Welch Allyn, Inc. 4341 State Street Road Skaneateles Falls, NY 13153 USA	URGENT: Field Safety Notice	2021-07-001-MKE-005
---	------------------------------------	---------------------

ELI@280, MLBUR280 and BUR280 Electrocardiographs

ELI@280 resting electrocardiograph - Patient mismatch/Software Upgrade

FSCA-identifier: 2021-07-001-MKE-005

Figure 1

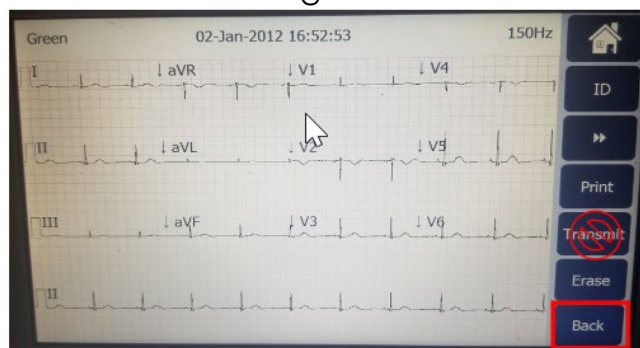
1. An ECG is acquired for Patient A and stored to the cardiograph.
2. An ECG is acquired for Patient B and stored to the cardiograph.
3. The ECG record associated with Patient A is retrieved from memory and any Patient Demographic information is edited.
4. After editing, the "Resting ECG" screen is presented as shown below. Figure 1
5. Pressing the TRANSMIT button from this screen (following any Patient Demographic edit) will transmit an ECG record other than for patient A. (see figure 2, which shows the Resting ECG screen).

If an ECG record is retrieved from the patient directory for a Patient Demographic edit to be performed, once the information has been edited and the screen above (Figure 1) is presented, do not press the transmit button. Instead, press the BACK button which will SAVE the changes to memory and present the user with the following screen, where the SYNC button can be used to transmit the desired record to the configured destination.

Figure3

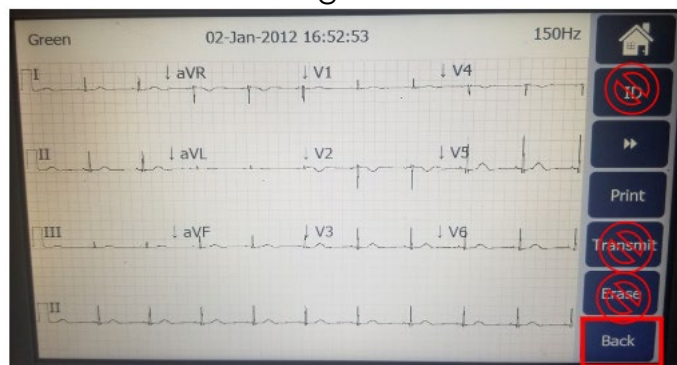
1. An ECG is acquired for Patient A and stored to the cardiograph.
2. An ECG is acquired for Patient B and stored to the cardiograph.
3. The ECG record associated with Patient A is retrieved from memory and ID information is edited.
4. After editing, the “Resting ECG” screen is presented as shown in Figure 3.
5. The user decides to make another ID Edit without leaving the “Resting ECG” screen and presses the “ID” button - Figure 3.

6. After the second edit is performed, the “Resting ECG” screen is once again presented as shown above.
7. Pressing the TRANSMIT button from this screen (following two ID edits in a row as defined above) will transmit an ECG record with the patient demographics
